Petition No. 1658
VFS, LLC
University of Connecticut
44 Weaver Road, Storrs (Mansfield), Connecticut

Interrogatories
May 1, 2025

Aerial Map

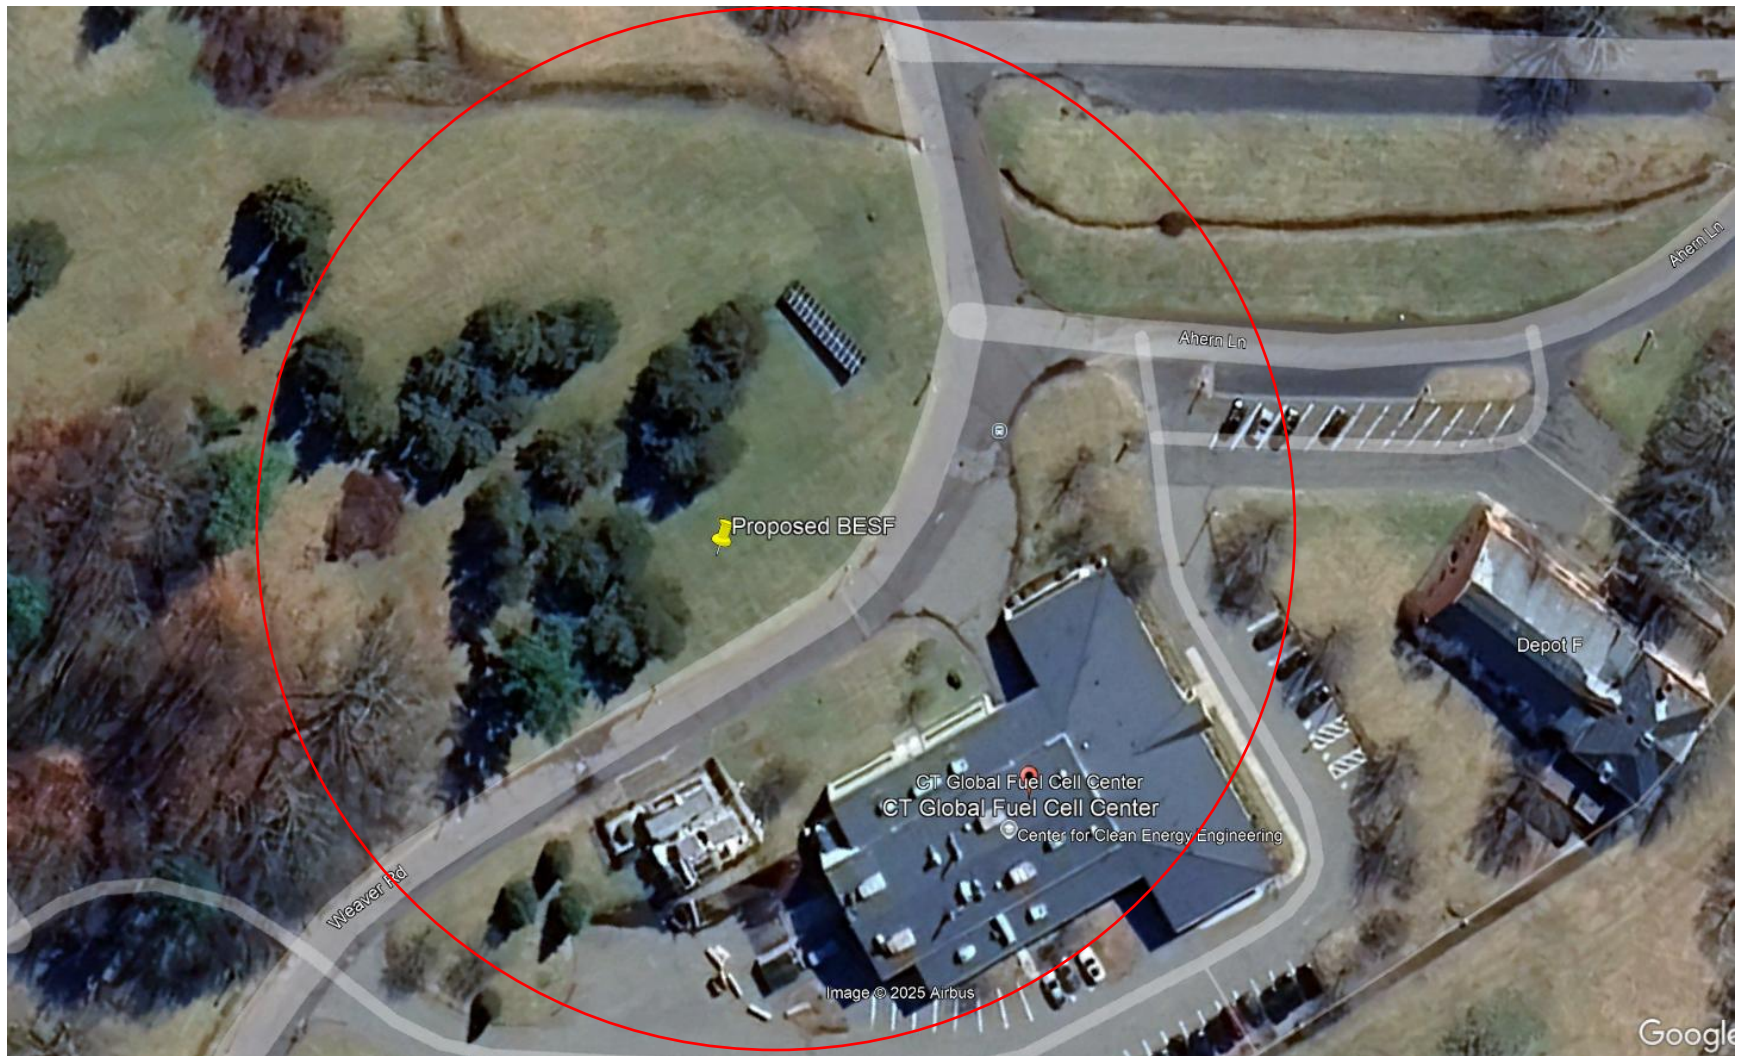
43. Referencing Petition Attachments 3 and 7, the site location designations on the respective maps do not match. Clarify.

49. Provide an aerial photograph that clearly shows the BESF location.

R43. See attached aerial map for correct location.

R49. See attached aerial photo
